Office Action Summary

10/674,622

This is the first office action for application number 10/674,622, Bottle Retainer, filed on September 30, 2003.

Claims 1-4 and 7-10 are rejected under 35 U.S.C. 102(b) as being anticipated by U.S. Patent number 5,655,673 to Weterrings et al.

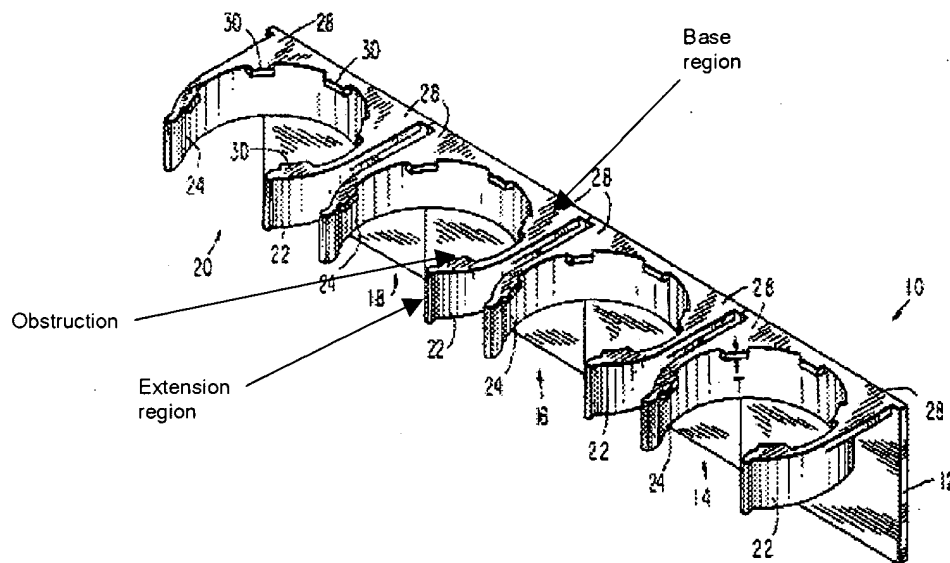
Weterrings et al. ⁶73 discloses a retainer (above) comprising a base having an affixing portion (12) and a retaining portion (14,16,18,20, generally) forming at least one opening/receiving means (between 22,24), the affixing portion having a back side and a front side, wherein the back side is adapted for mounting the retainer to a surface, wherein the opening is inherently adapted to slidably receive a bottle therein, wherein the retaining portion further comprises at least three bifurcated arms/receiving means (22,24, above) wherein the arms form at least two openings (between 22,24 above) that can inherently slidably pass bottles therethrough, wherein the bifurcated arms have a base region (above) and an extension region (above), wherein the bifurcated have at least one obstruction (above) positioned on the extension region in coordination with the openings thereby inherently restricting accidental bottle disengagement, wherein the back side of the affixing portion further includes an adhesive layer (32) that is adapted

to mount the retainer to a surface, wherein the at least two openings are equivalent in size.

Claims 1, 2 and 5 are rejected under 35 U.S.C. 102(b) as being anticipated by U.S. Patent number 2,921,690 to Smith et al.

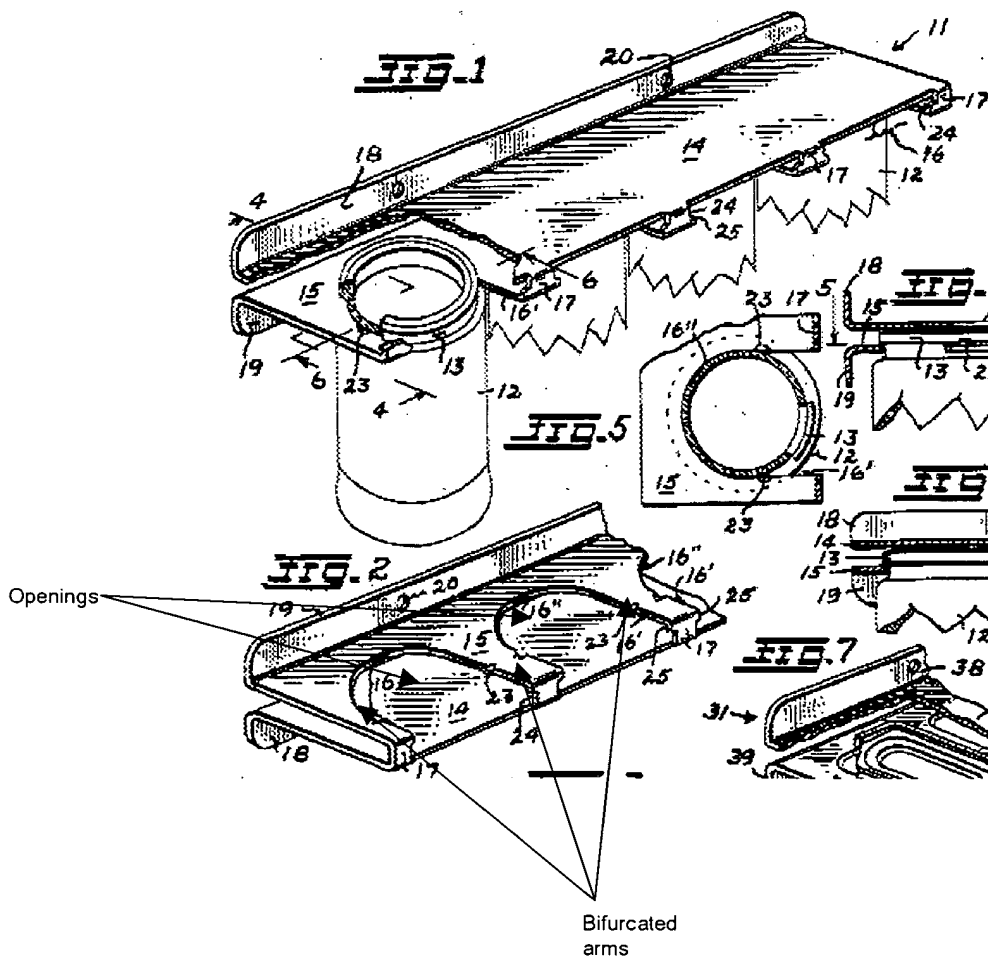
Smith et al. '690 discloses a retainer (above) comprising a base having an affixing portion (19) and a retaining portion (15, generally), the affixing portion having a

back side and a front side, the back side for mounting the retainer to a surface (column 2, lines 26-30), the retaining portion forming at least one opening (above) that is inherently adapted to slidably receive a bottle therein, wherein the retaining portion further comprises at least three bifurcated arms (above) that form at least two openings inherently for slidably passing bottles therethrough, wherein the affixing layer/portion is further inherently adapted to allow at least one nail to pass therethrough (through portion 20) so as to mount the retainer to a surface.

Claims 1, 2 and 6 are rejected under 35 U.S.C. 102(b) as being anticipated by U.S. Patent number Des. 262,504 to Flynn.

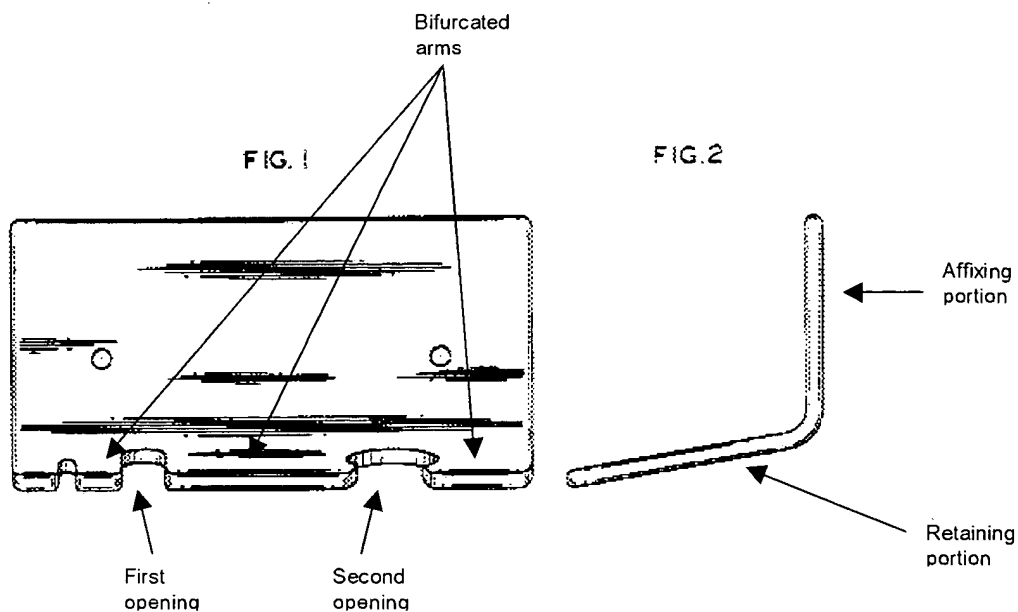
Flynn '504 discloses a retainer (above) comprising a base having an affixing portion (above) and a retaining portion (above), the affixing portion having a back side and a front side, the back side can inherently mounting the retainer to a surface, the retaining portion forming at least one opening (above) that is inherently adapted to

slidably receive a bottle therein, wherein the retaining portion further comprises at least three bifurcated arms (above) that form at least two openings inherently for slidably passing bottles therethrough, wherein the first opening is smaller than the second opening.
